HISTORIC DISTRICT COMMISSION

NOTICE OF DENIAL

Application Number: HDC2025-00729

NAME: Peter Markaj		COMPANY NAME: N/A	
ADDRESS: 2050 Atkinson	CITY: Detroit, Michigan 48206	STATE: MI	ZIP: 48206
PROJECT ADDRESS: 2050 Atkinson			
HISTORIC DISTRICT: Atkinson Avenue			
SCOPE: Remaining work items.

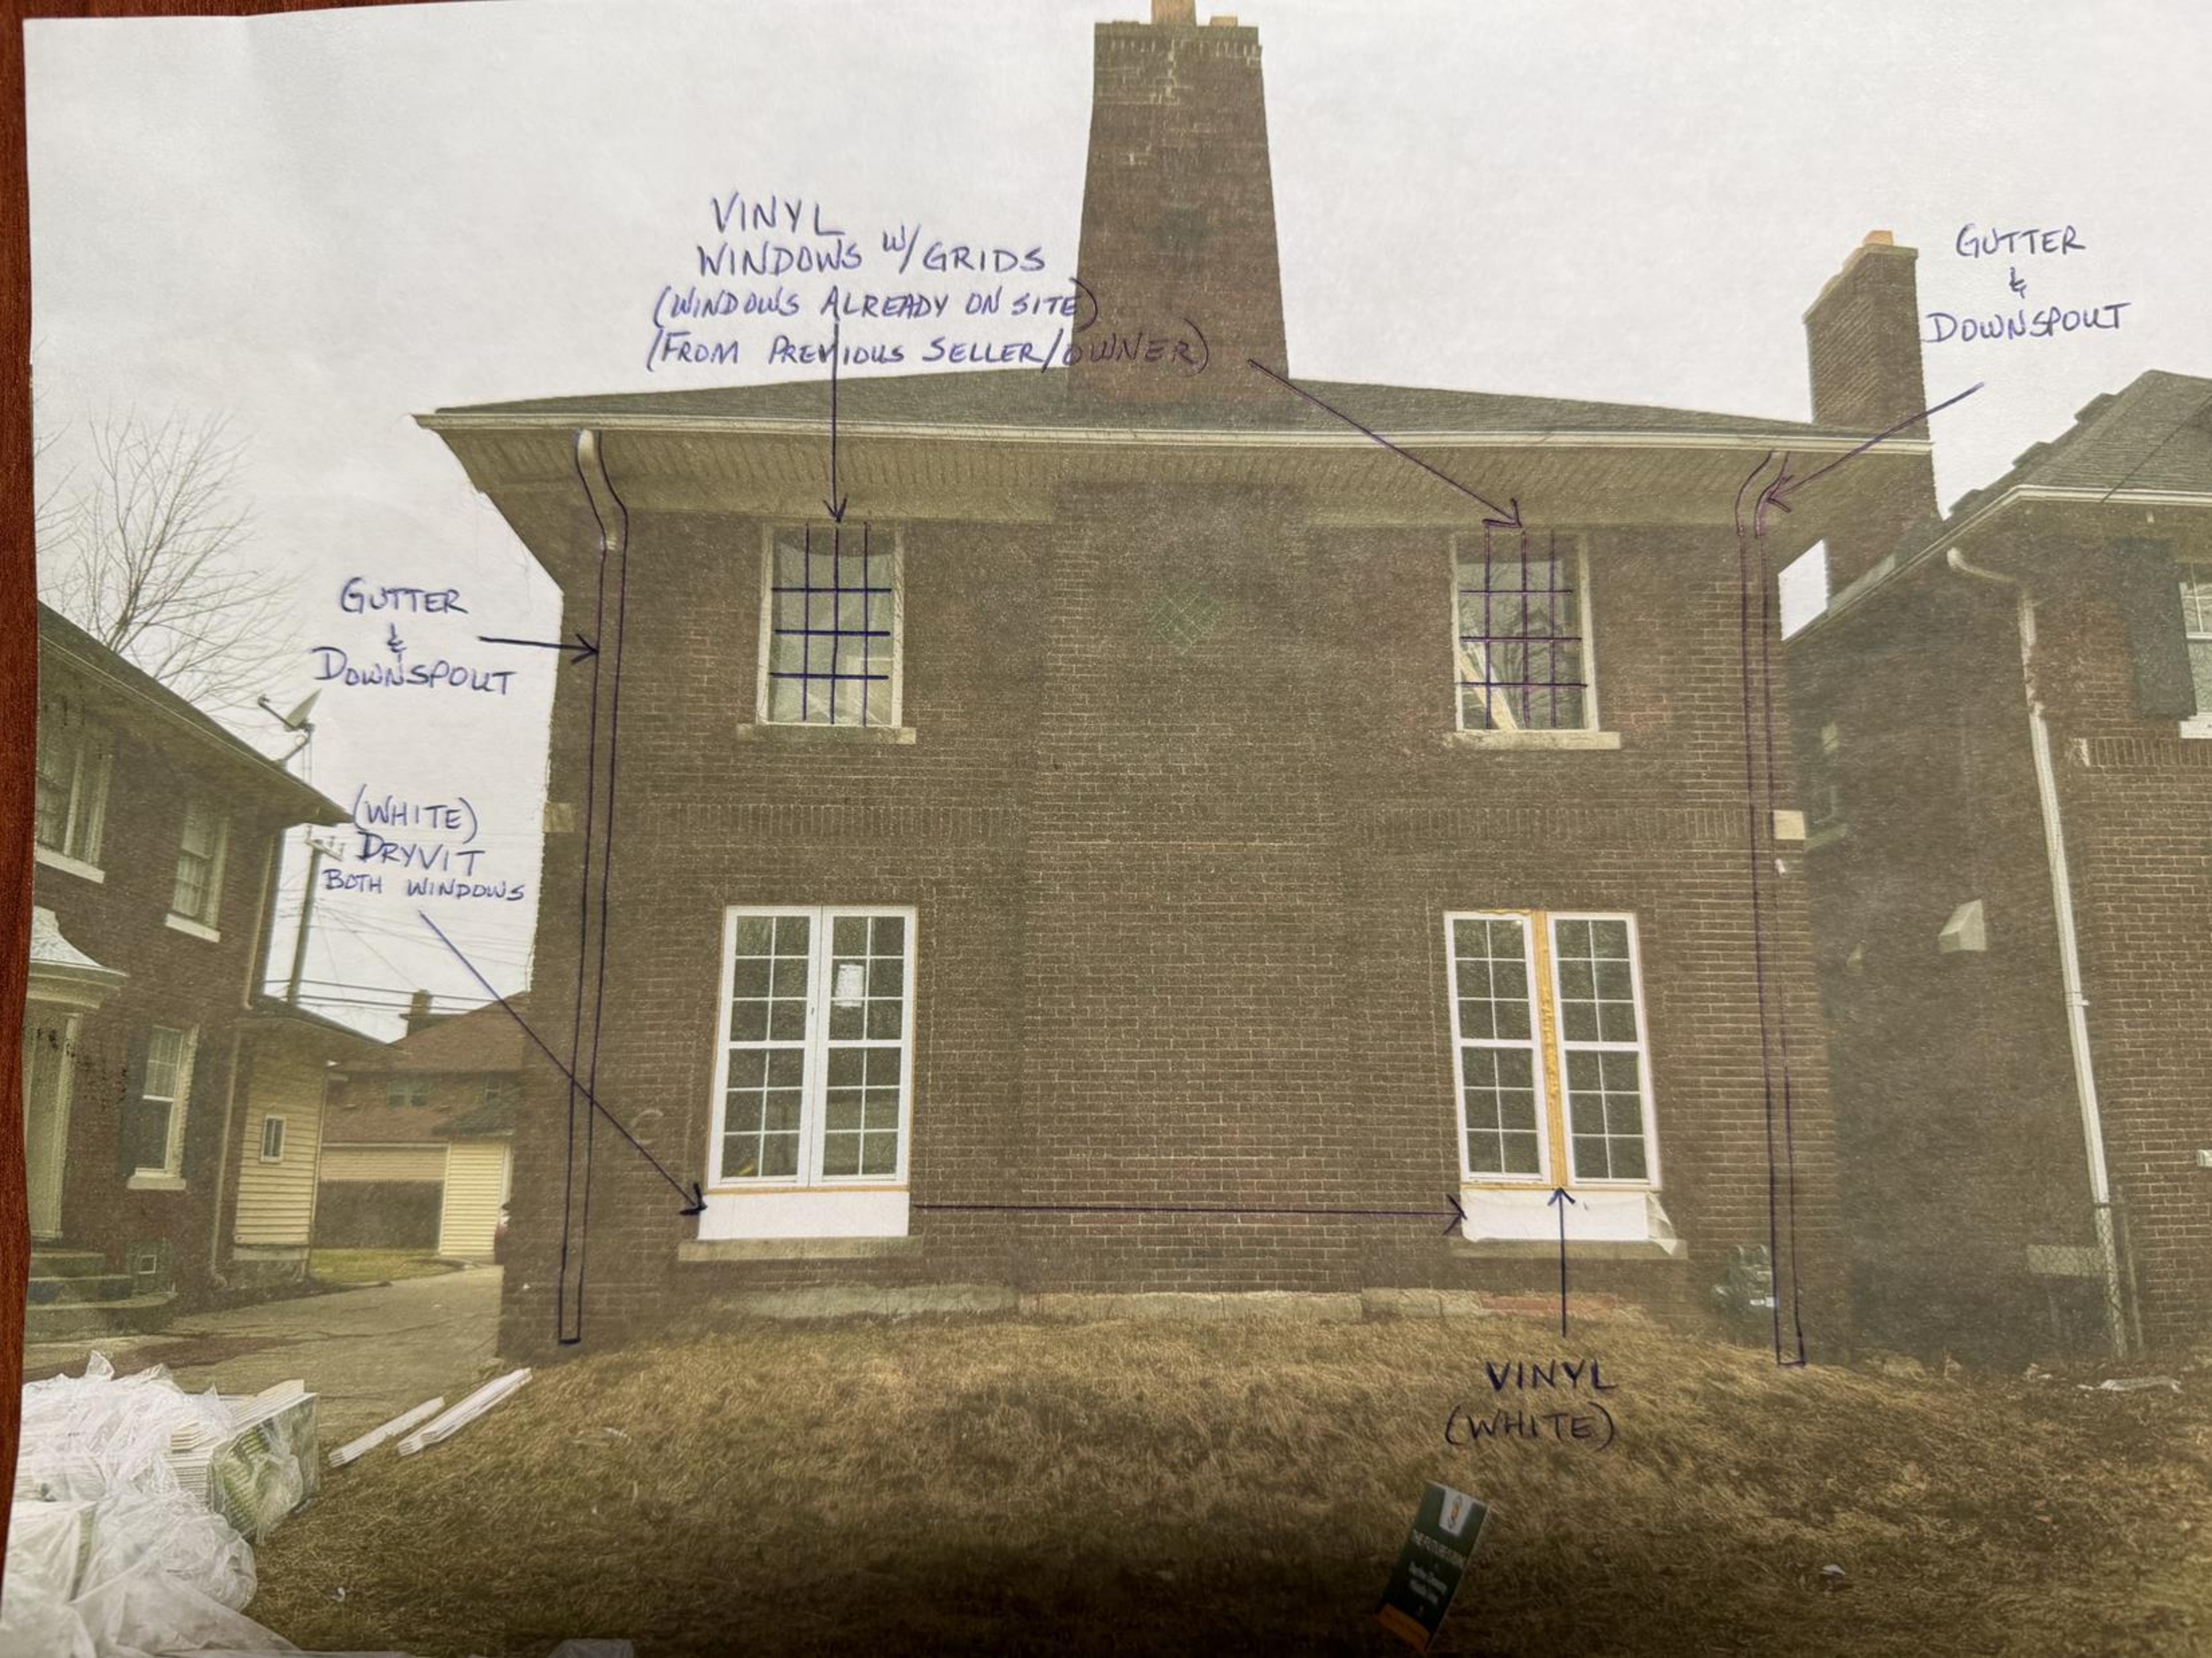
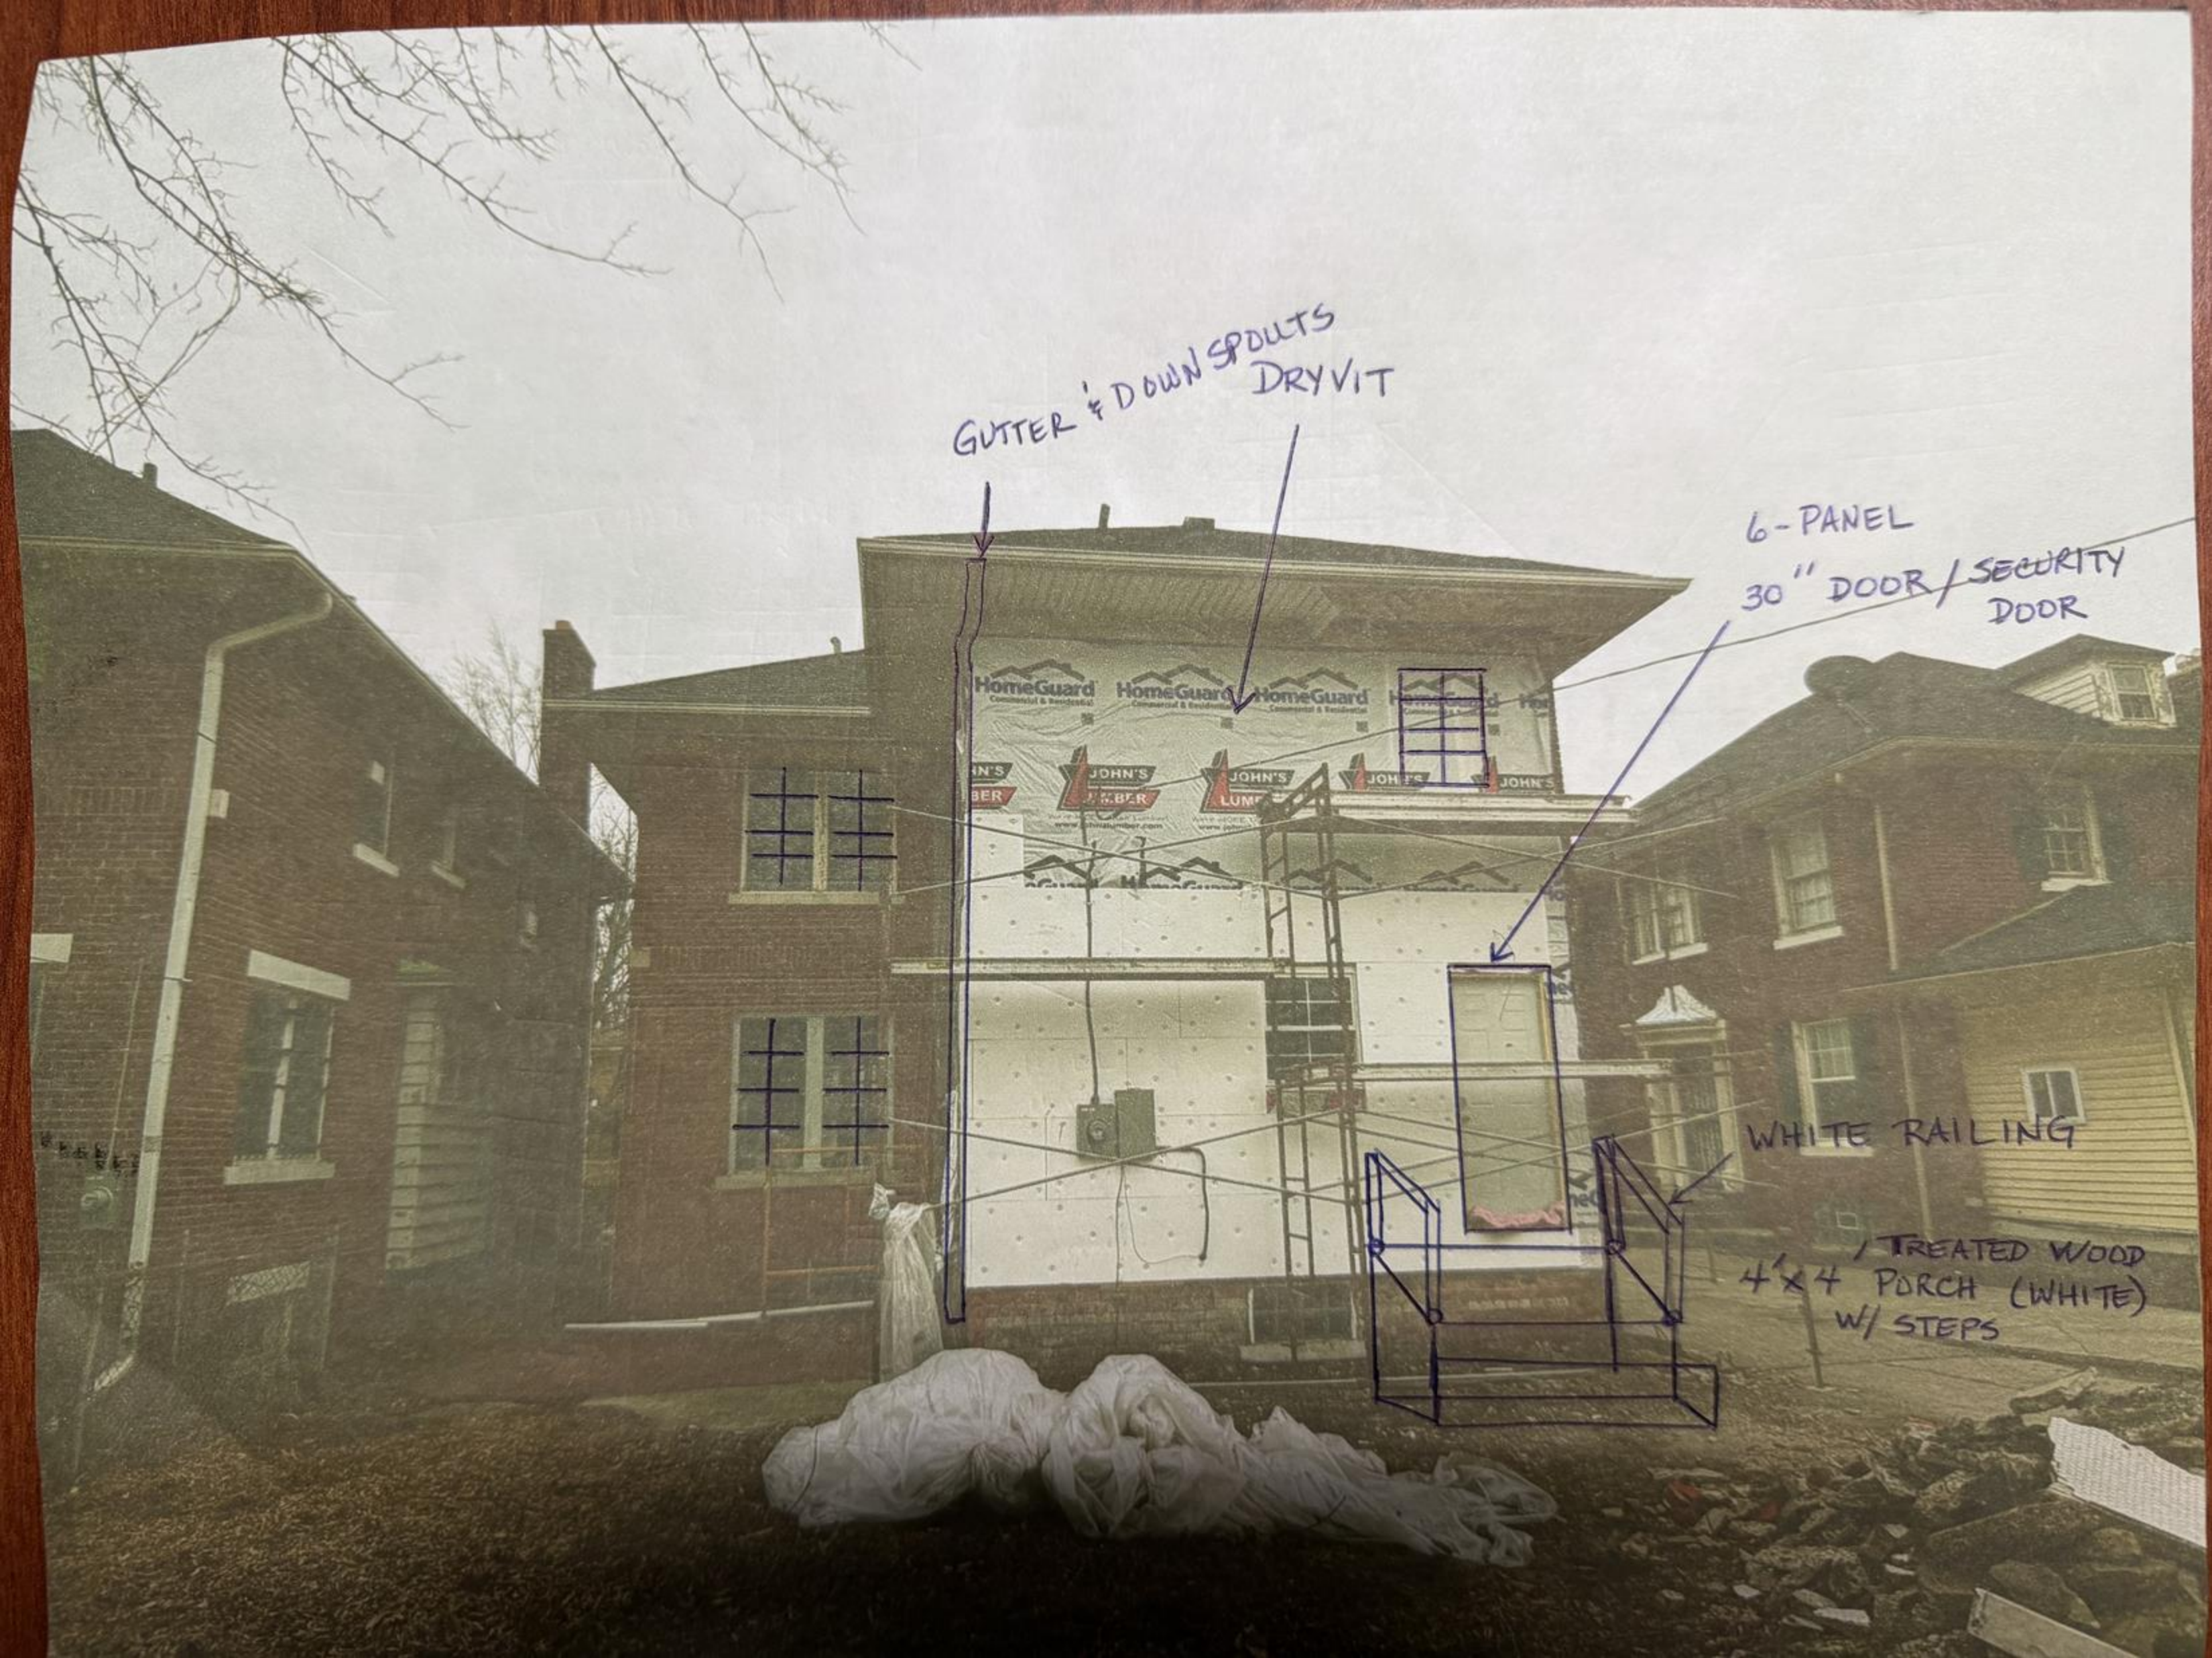
The pattern drawn in the windows give the effect of casement windows, not double-hung sash, as there is no identified central/thicker meeting rail. The one double-hung window already installed on the side (west) wall has a six-over-six pattern; however, the drawn in windows, if double-hung, show a twelve-over-twelve pattern. Please confirm.

Please submit a dimensioned drawing to detail what is planned for above the entry. Are you building something or proposing to install a manufactured item?

Attached are the drawings for the proposed window installation with the same number of grids as on the front of the home and the others on other sides of the home are 4 and 4 grid patterns. The windows to be installed are manufactured by Pella Windows and were on site at time of purchase. All the windows are single hung and would match the ones already installed. Spec sheets have been requested from Pella to submitted upon receipt.

Above Entry Door - would be custom made and will be similar to ones in the area of same style and designs.
